**PCN#20230213000.0
Symbolization update for select TSSOP devices
Information Only**

PCN Number:	20230213000.0	PCN Date:	February 14, 2023
Title:	Symbolization update for select TSSOP devices		
Customer Contact:	PCN Manager	Dept:	Quality Services
Change Type:			
<input type="checkbox"/>	Assembly Site	<input type="checkbox"/>	Assembly Process
<input type="checkbox"/>	Design	<input type="checkbox"/>	Assembly Materials
<input type="checkbox"/>	Test Site	<input checked="" type="checkbox"/>	Datasheet
<input type="checkbox"/>	Wafer Bump Site	<input type="checkbox"/>	Packing/Shipping/Labeling
<input type="checkbox"/>	Wafer Fab Site	<input type="checkbox"/>	Mechanical Specification
		<input type="checkbox"/>	Test Process
		<input type="checkbox"/>	Wafer Bump Material
		<input type="checkbox"/>	Wafer Bump Process
		<input type="checkbox"/>	Wafer Fab Materials
		<input type="checkbox"/>	Wafer Fab Process
		<input type="checkbox"/>	Part number change

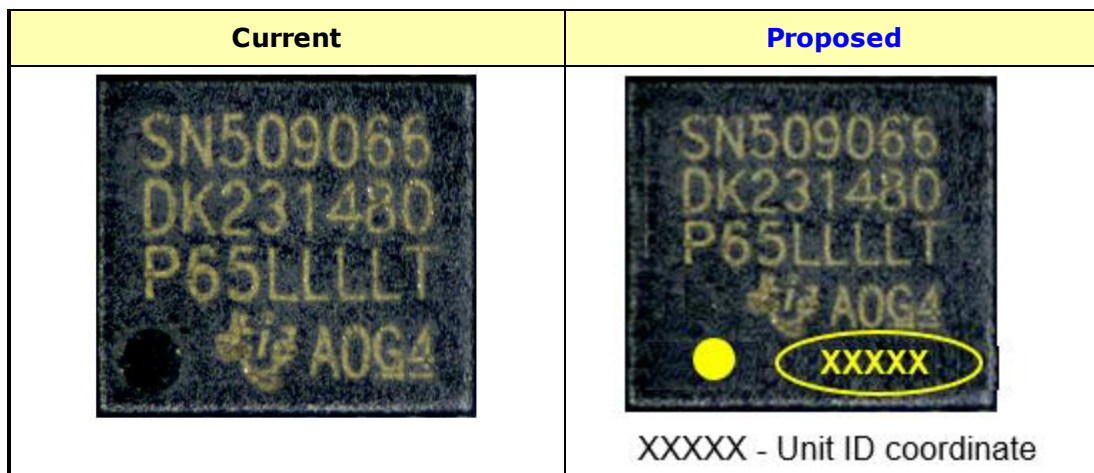
This letter is to inform customers of a device symbolization change for select devices in the TSSOP package that will enable enhanced device level traceability as follows:

Added device symbolization row
